# **Intel<sup>®</sup> Mobile Celeron<sup>™</sup> Processor Specification Update**

Release Date: November 1999

Order Number: 244444-009

Figure 5.3. Surface-Mount BGA1 Package—Top and Side View

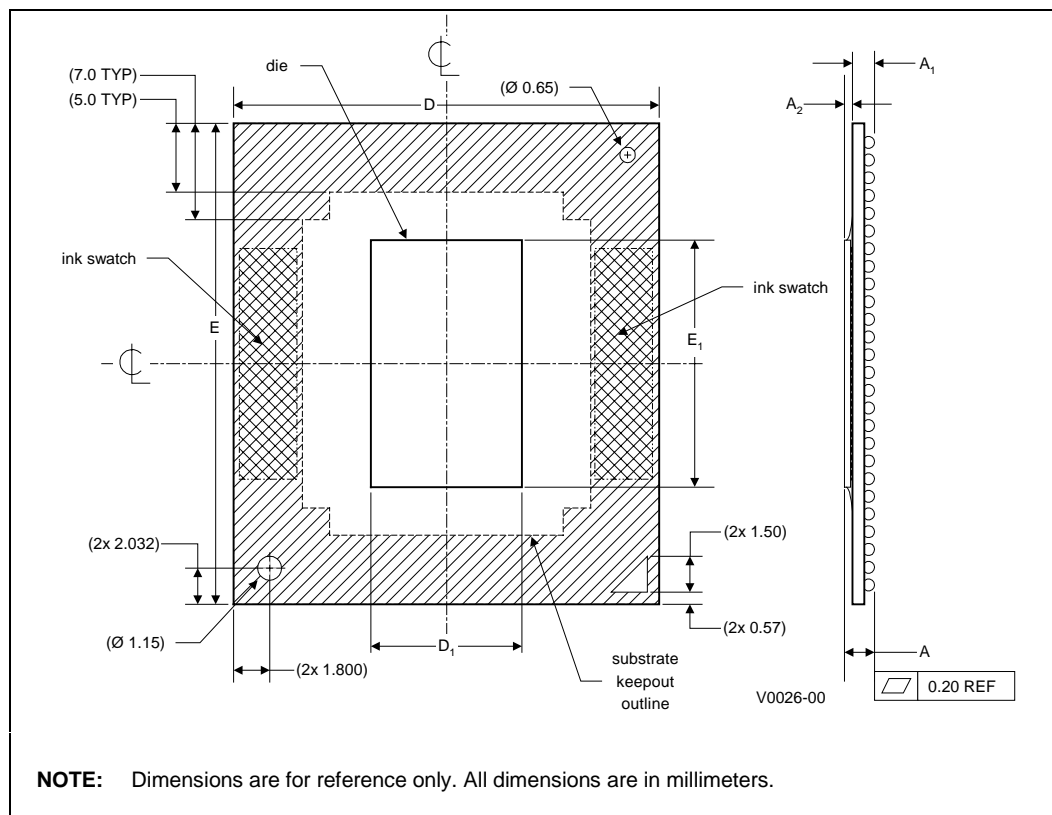
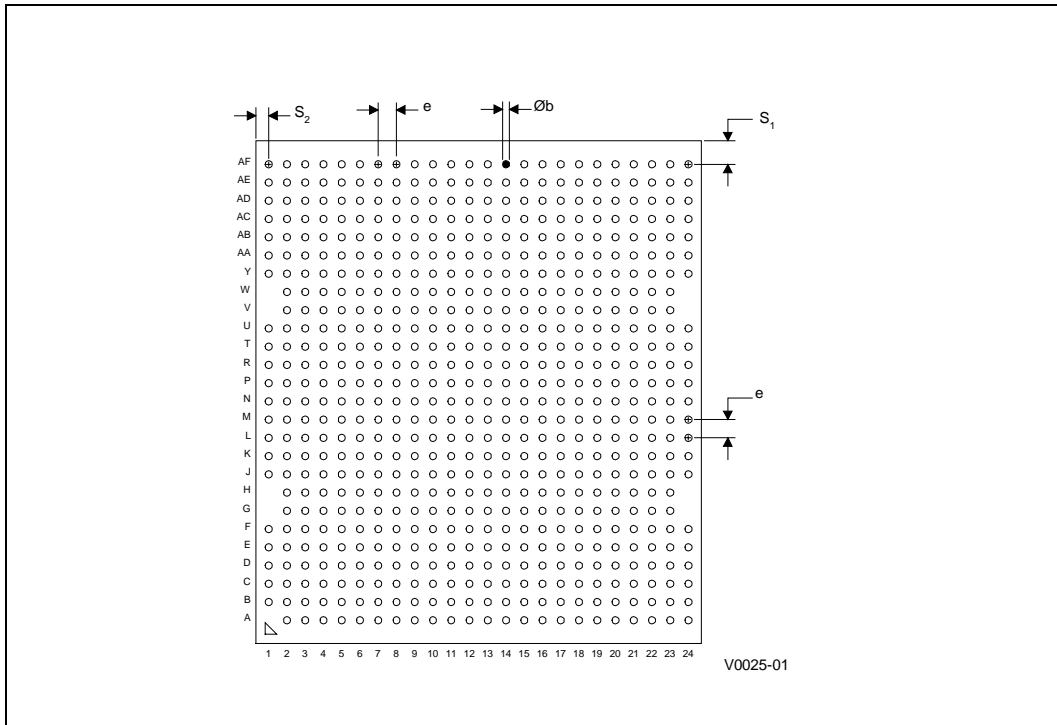
The following table and figures show the updated mechanical specifications for the BGA1 package, listed as Table 5.2, Figure 5.3 and 5.4, respectively, in the *Intel® Mobile Celeron™ Processor in BGA Package at 333 MHz, 300 MHz and 266 MHz* datasheet.

1. The number shown here is different from that in the 244444-004 version of this specification update. The maximum reference number is used.

Figure 3.3 Generic Clock Waveform

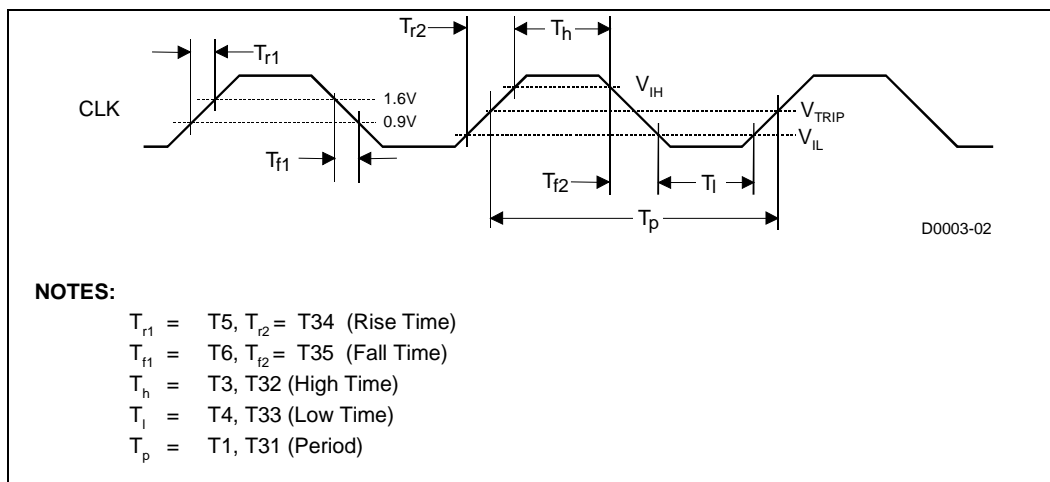
## H11. Generic Clock Waveform Figure

Figure 3.3 in the *Intel® Mobile Celeron™ Processor in  $\mu$ PGA1 and BGA1 Packages at 366 MHz, 333 MHz, 300 MHz, and 266 MHz* datasheet (Order Number 245112-003) has been updated. The following figure is to replace the one in the above document.
